Gatwick Airport Northern Runway Project

Design and Access Statement – Volume 3

VERSION: 2.0

SCHEDULE OF CHANGES

Figure 2. Works by Land Use Type and Key Developments

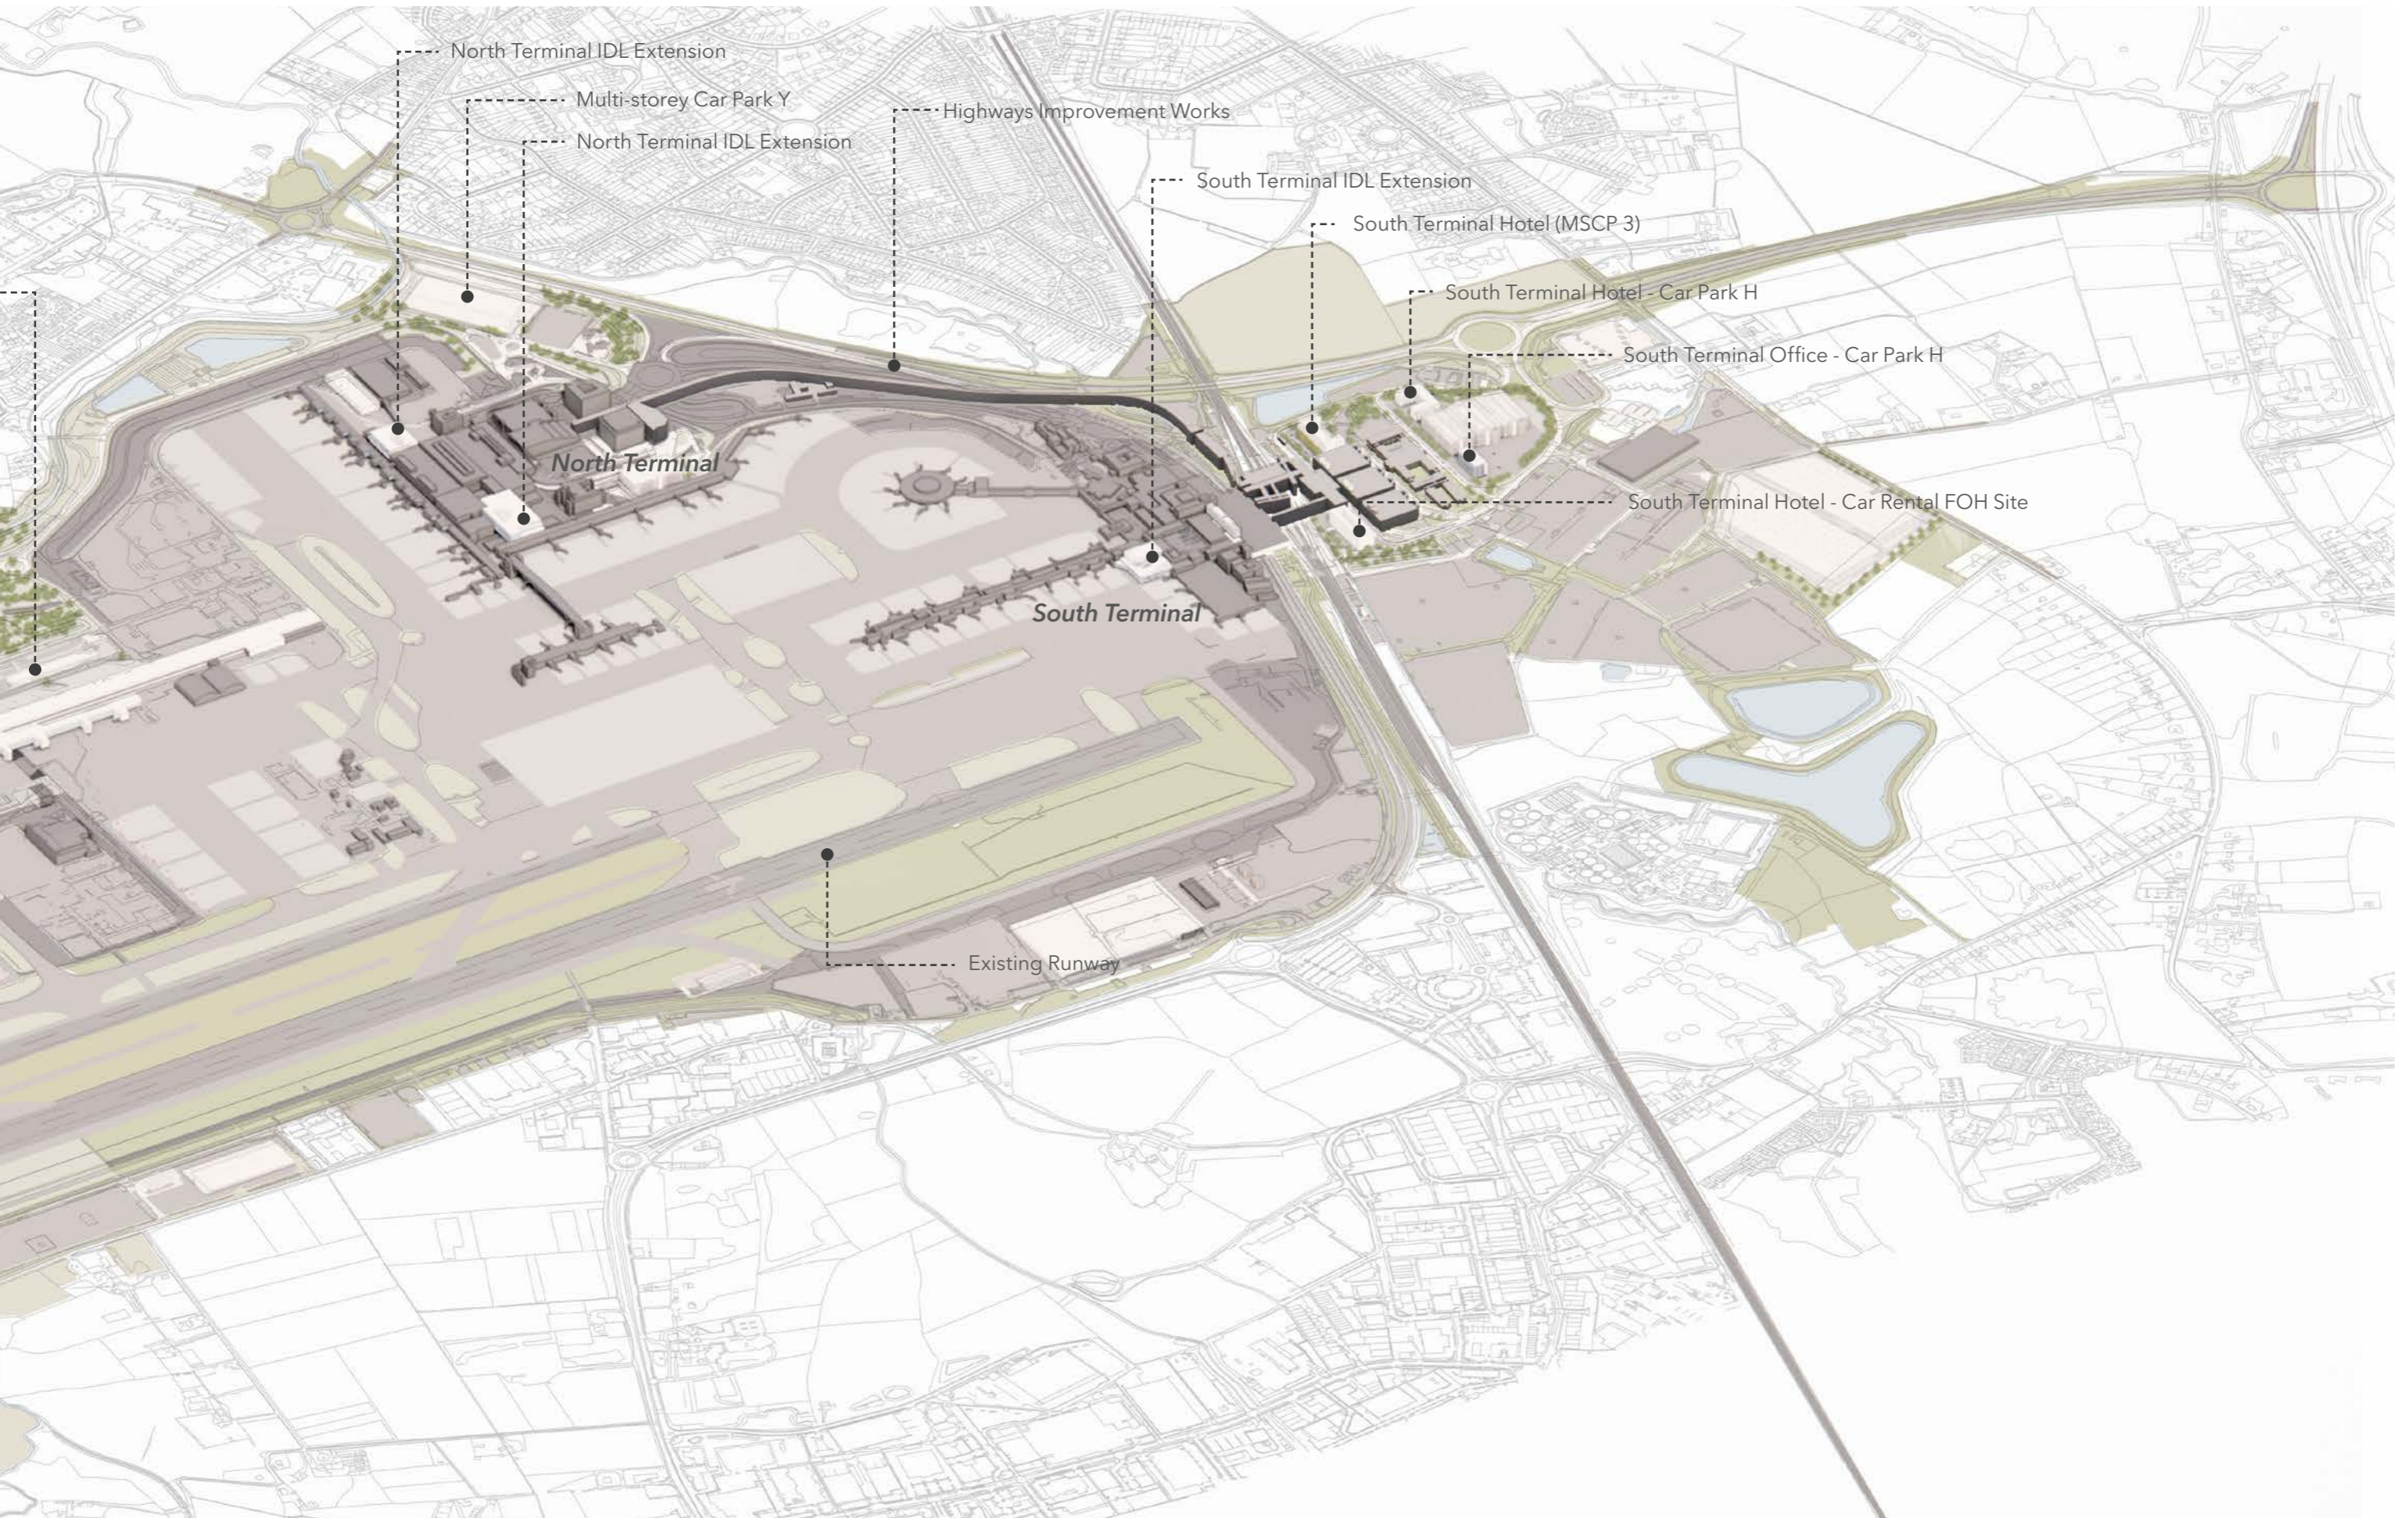
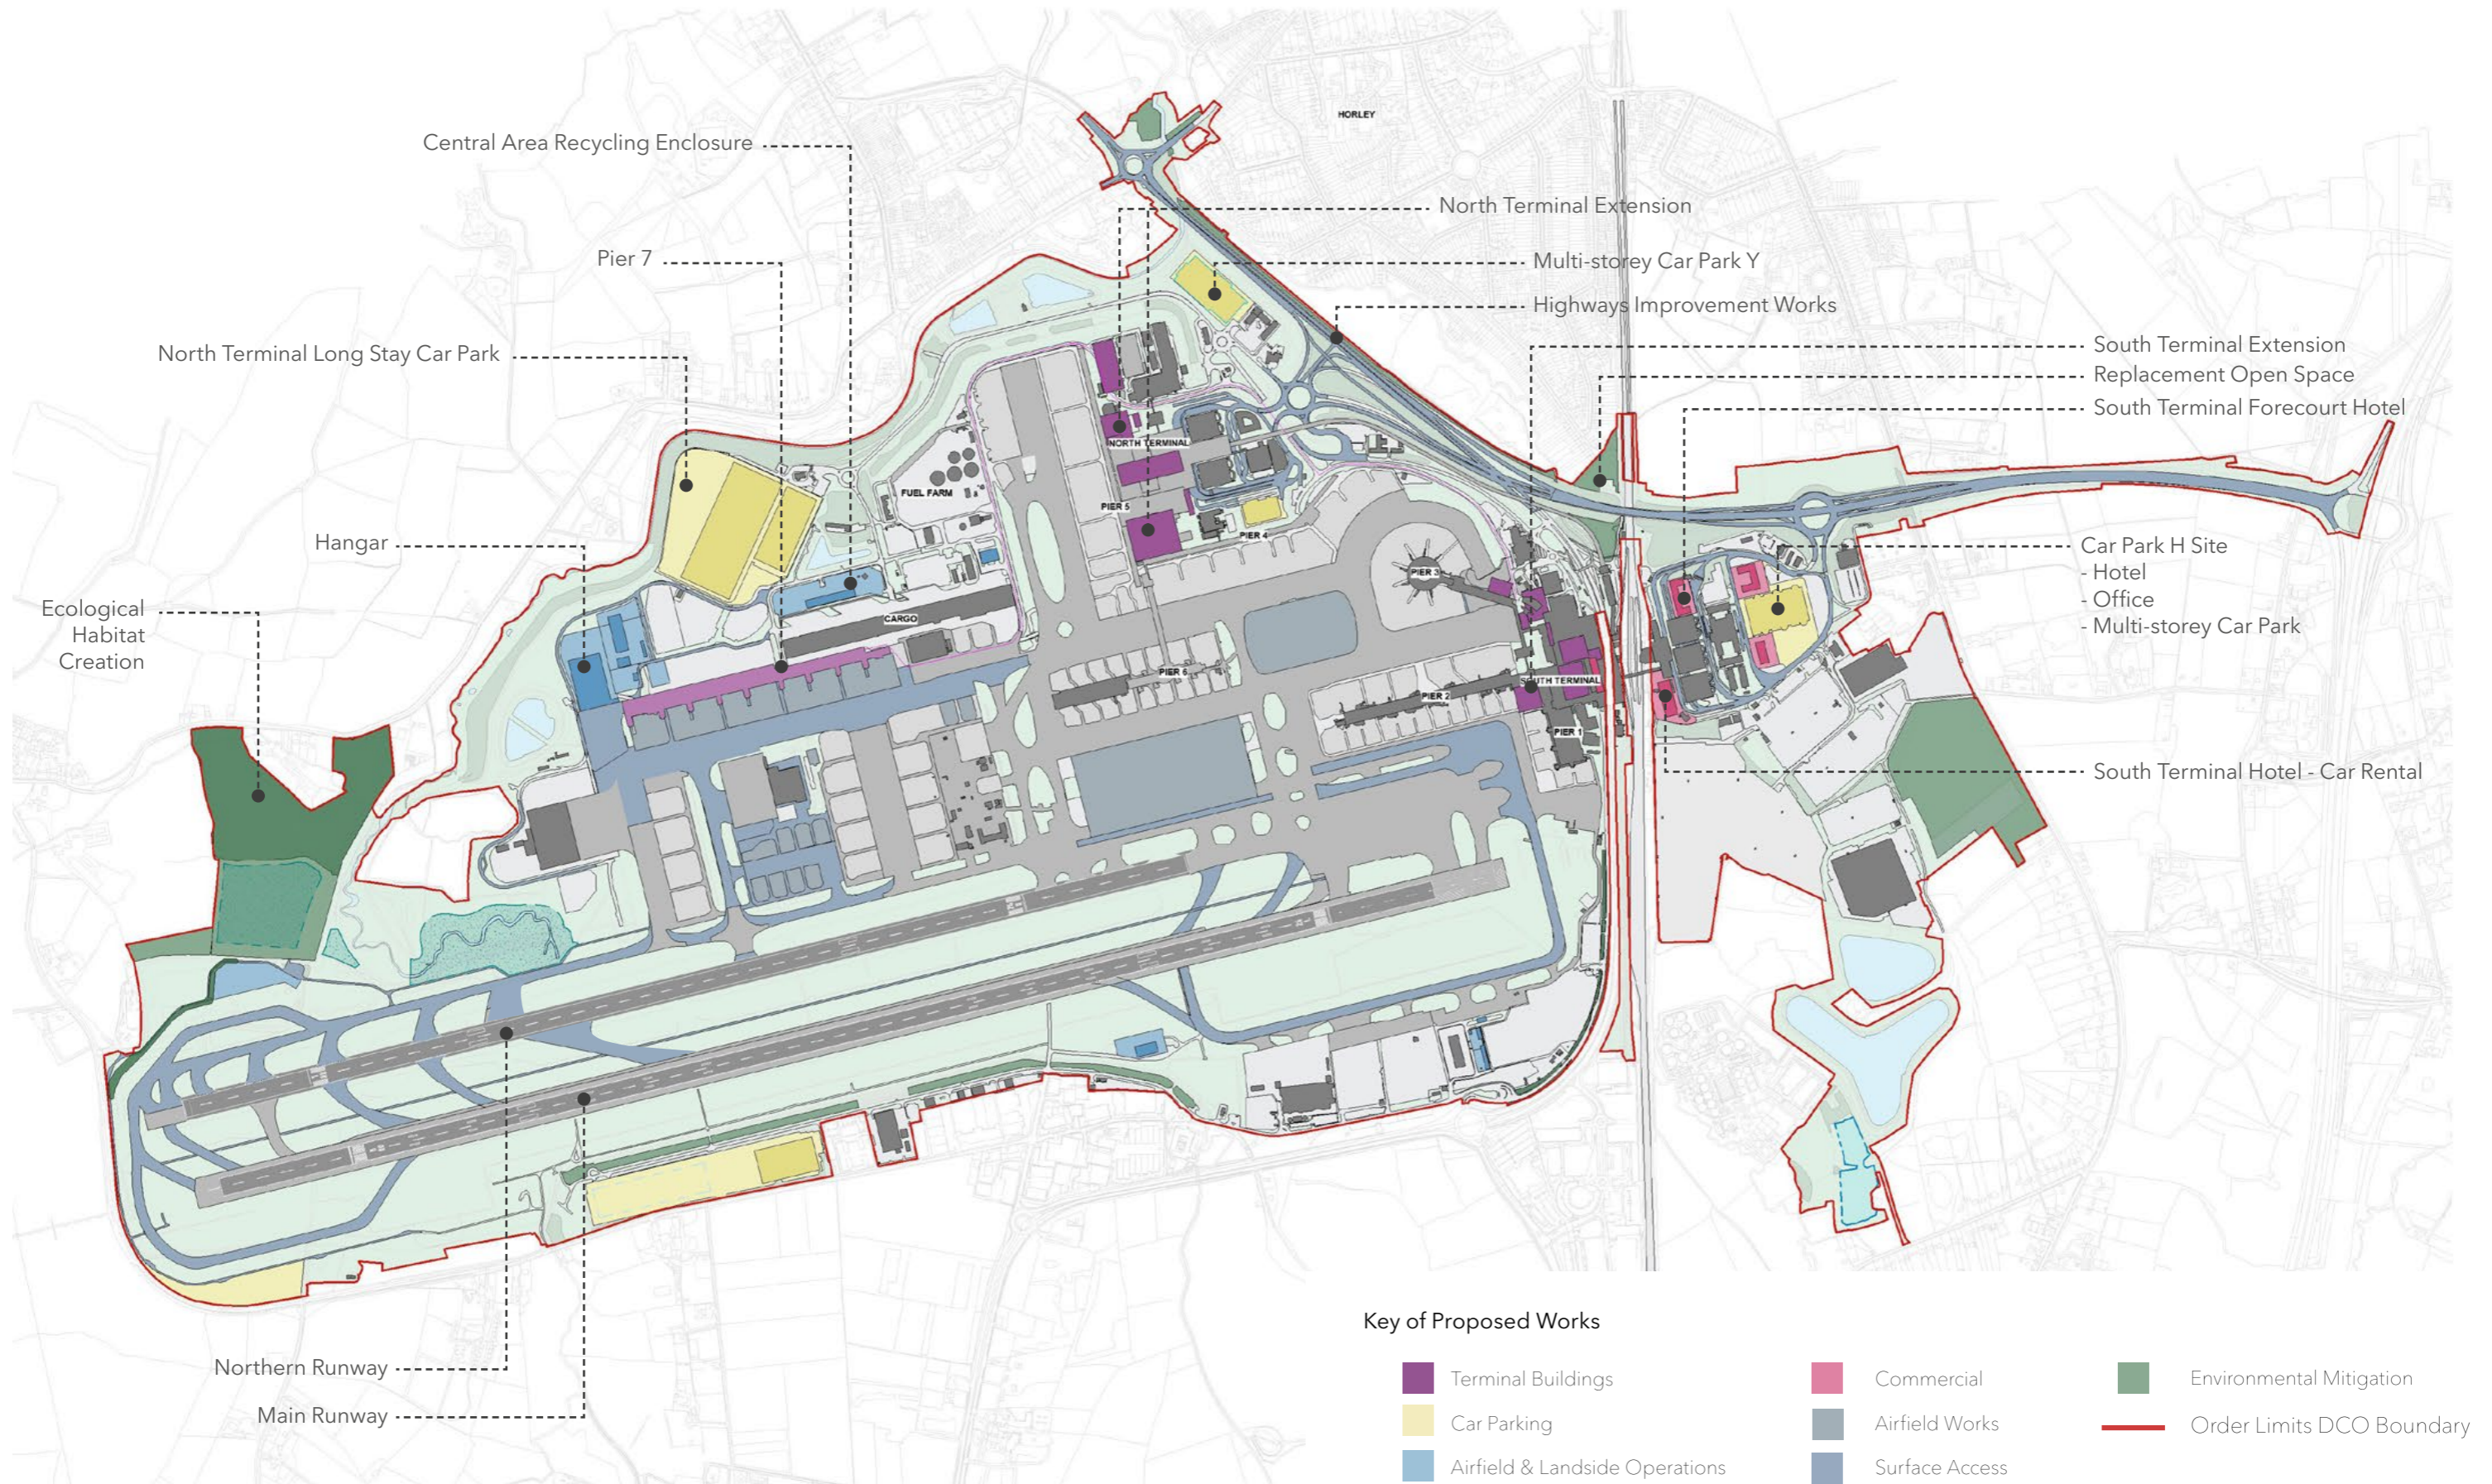
Change No.	Page No.	Figure/Text Ref.	Description
3.1	4	Figure 2	Land Use Diagram - Water Treatment Works changed to reflect different land use allocation.

Figure 9. Illustrative View of Northwestern Zone Location

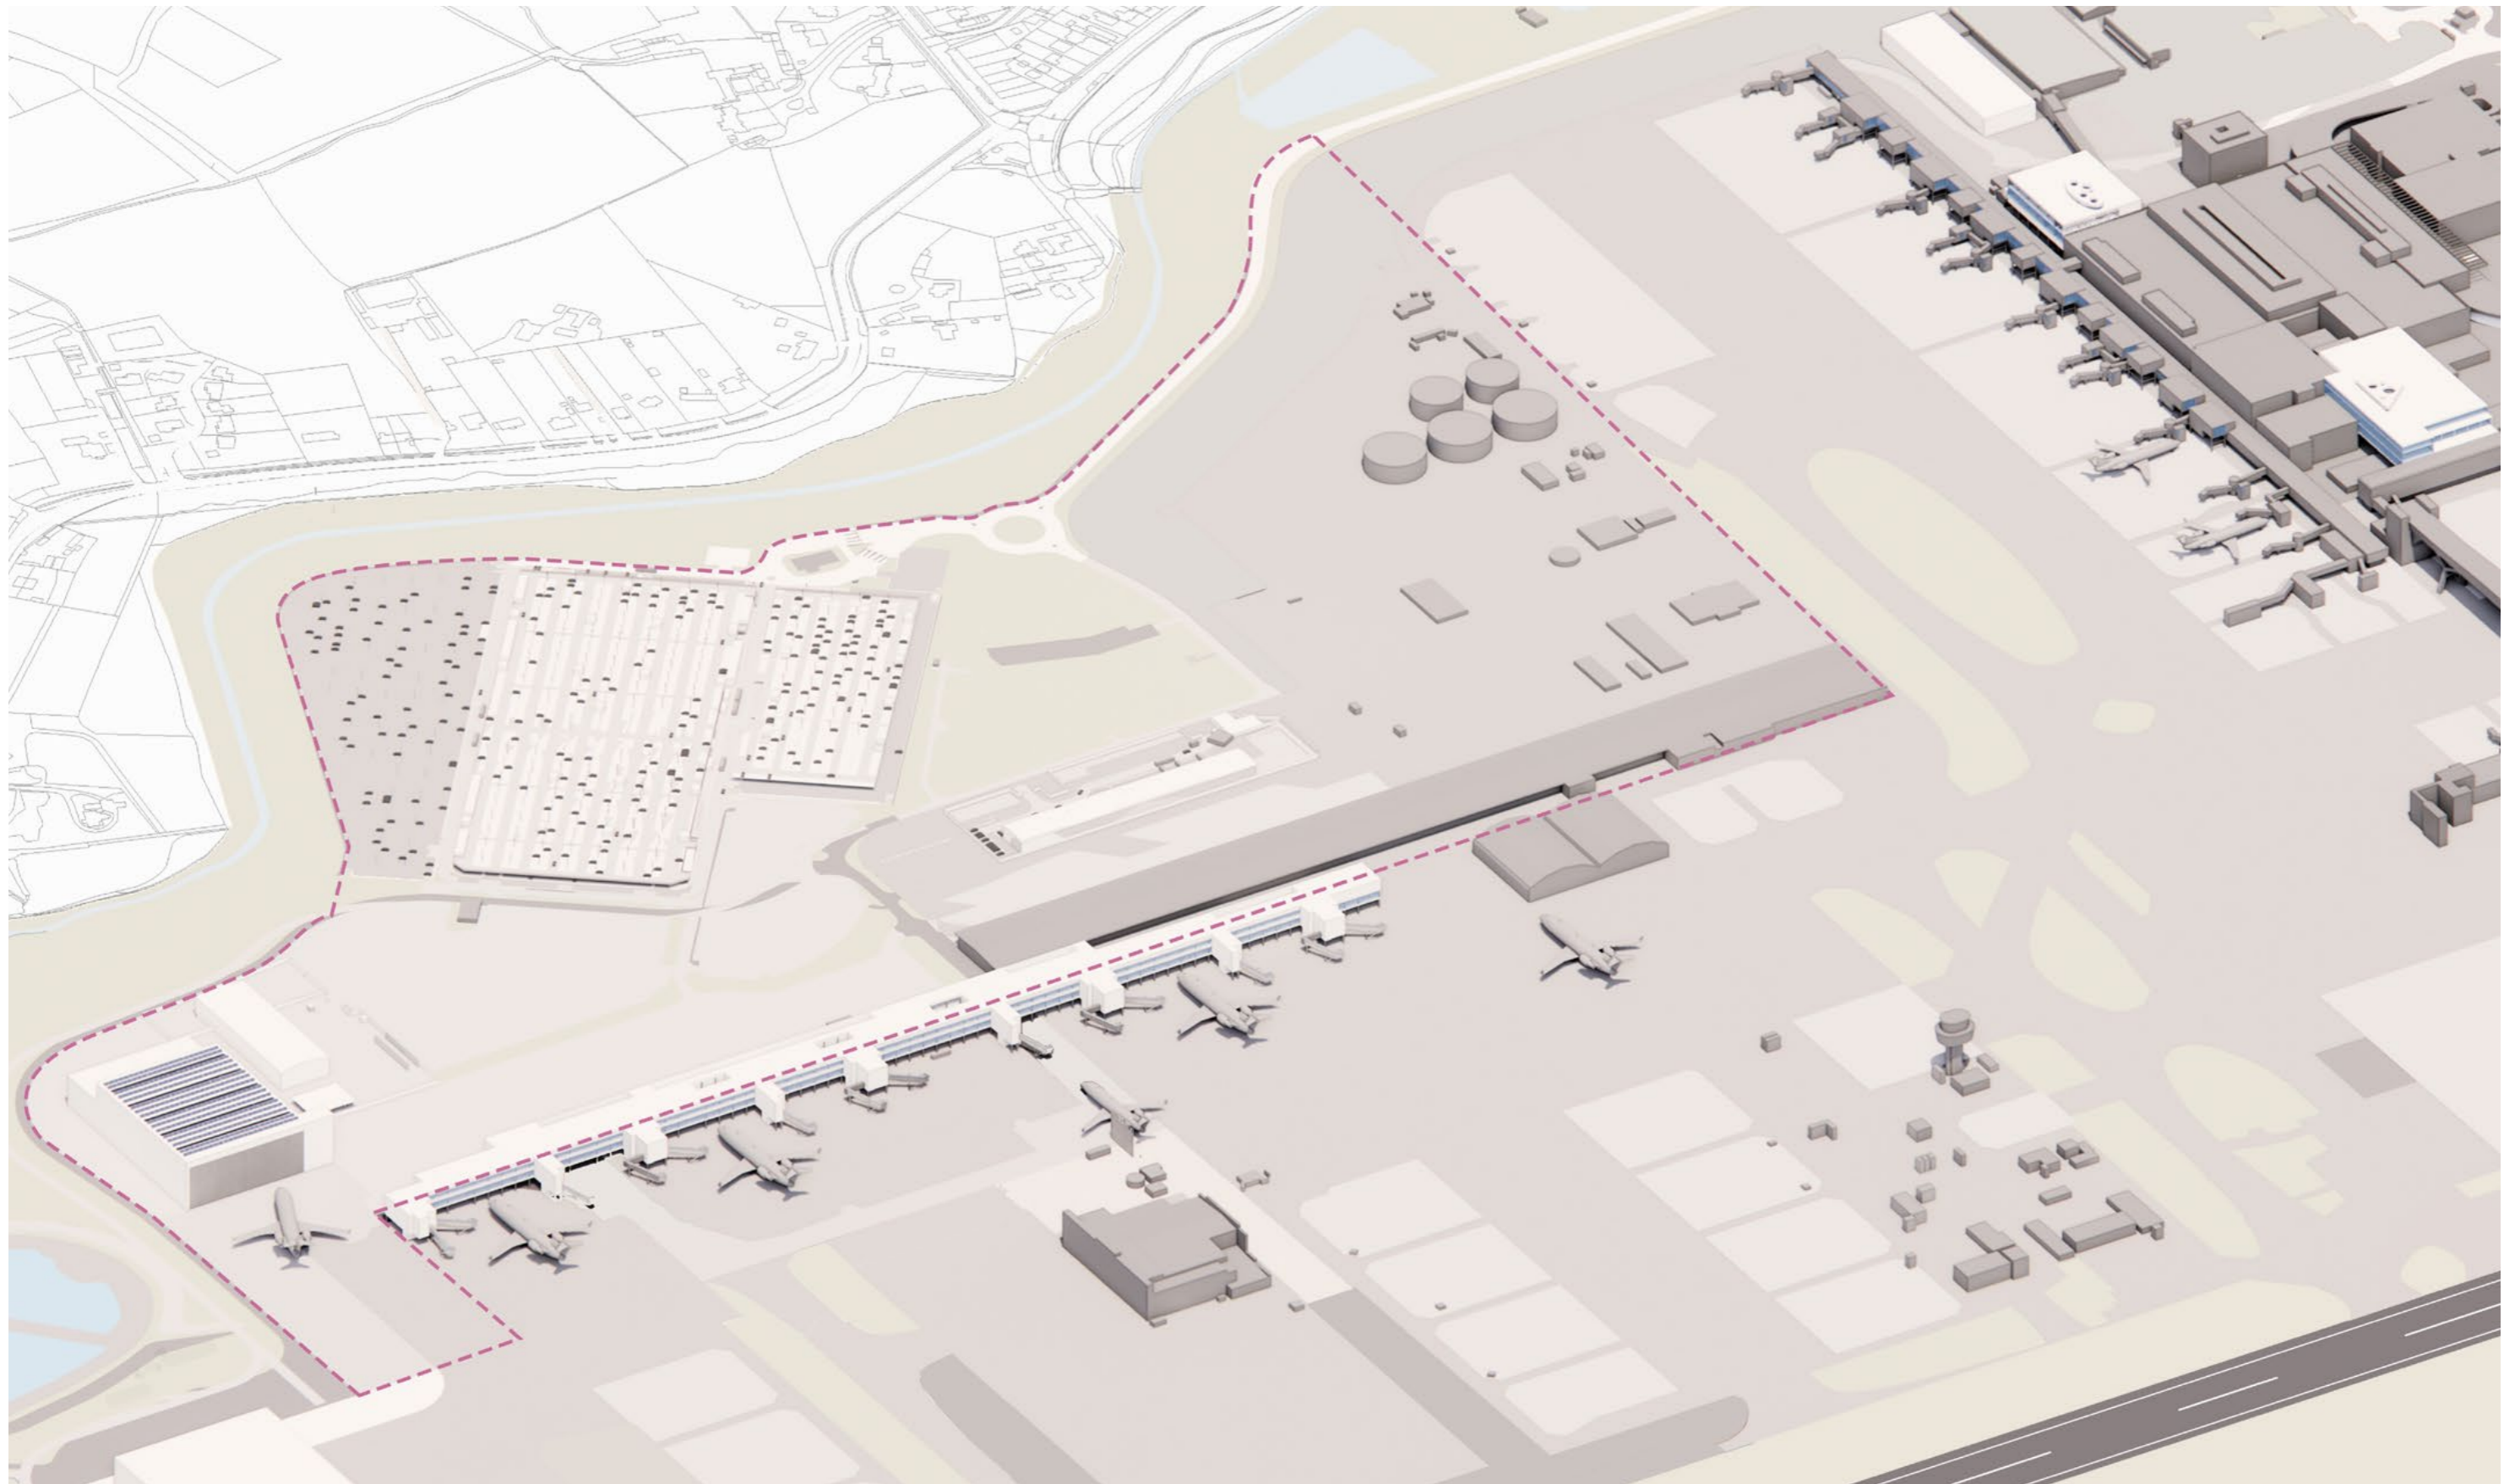
3.2	9	Figure 9	Indicative visual changed to reflect that a biomass boiler and associated flue is no longer proposed.
3.3	12	5.6.4.2	Text changes to reflect that a biomass boiler and associated flue is no longer proposed.
